MPI Policy and Trade

Including EcoPond Generation 2 for dairy cattle

Author: Sophie Mead, Policy Analyst, Greenhouse Gas Inventory Team

Purpose of this paper

Figure 3: Results of the Capstone trial following the three treatments (November 2024, January and March 2025).

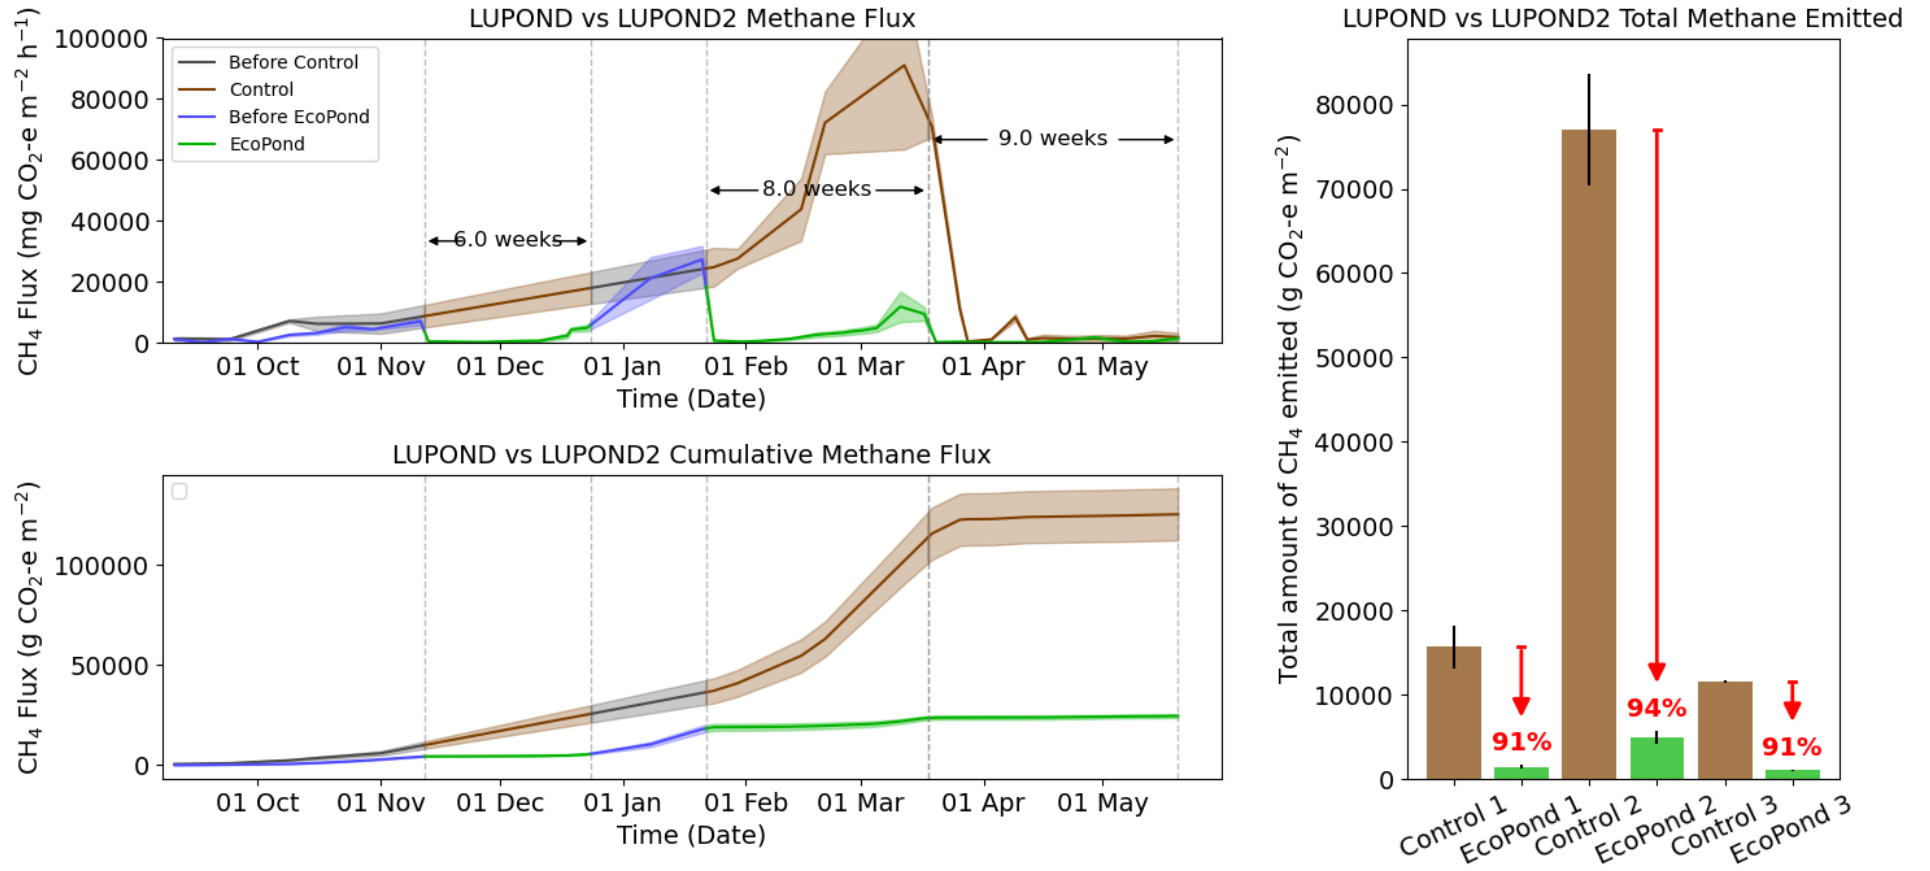
18. Each dosage lowered methane emission flux by 91 – 94%, and that effect lasted from 6 – 9 weeks before methane emissions began to increase again and another dosage was needed.

- a. Treatment from the 12th of November reduced the pond's methane emission flux by 91% during the subsequent 6 weeks following the dosage.
 - b. In the 8 weeks following the second dosage of the pond (January 2025) the methane emission flux decreased by over 94%.

- c. In the 9 weeks following the third dosage of the pond (March 2025), the methane emission flux decreased by over 91%.
19. The results of this capstone trial can be viewed in figure 3.

20. The mean reduction across the three treatments was 92%.

- A 6-week efficacy period.
48. The capstone trial demonstrated a strong reduction in methane emissions (91–94%), with each treatment lasting 6 to 9 weeks. While additional field trials have been conducted, the variation observed between those results and the capstone trial have not been fully explained. On that basis, and given the primacy of the capstone findings, we are proposing to use a 92% efficacy. This is the mean value of the three treatments in the capstone trial.
